Re: 106 Cliff Ave., Capitola, CA – Final Secretary of the Interior's Standards Compliance

Review; APN. 036-112-17

Figure 9. Undated image of the subject property, showing the open porch and entrance on the west elevation.

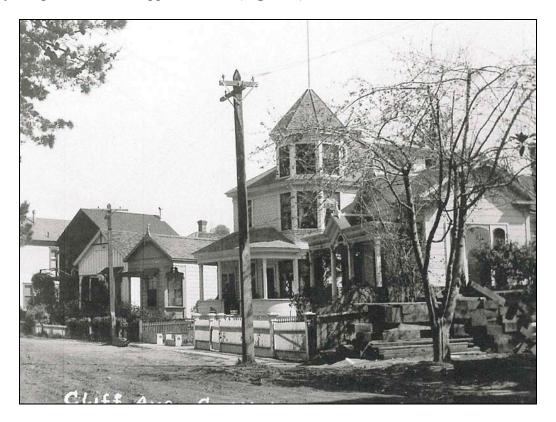
- 1. The details of the porch replacement and first-floor windows, such as the type/configuration of the windows and the type/style of the wood columns are not detailed on the drawings. It is recommended that the architect provide this information in a proposed porch detail, based on the photographic evidence that exists (see **Figure 9**).
- 2. Provide dimensions of the rear addition's existing and proposed wood wall cladding, including the proposed upper-floor shingle pattern and the proposed lower-floor wood siding exposure width to ensure it differentiates from the historic house.
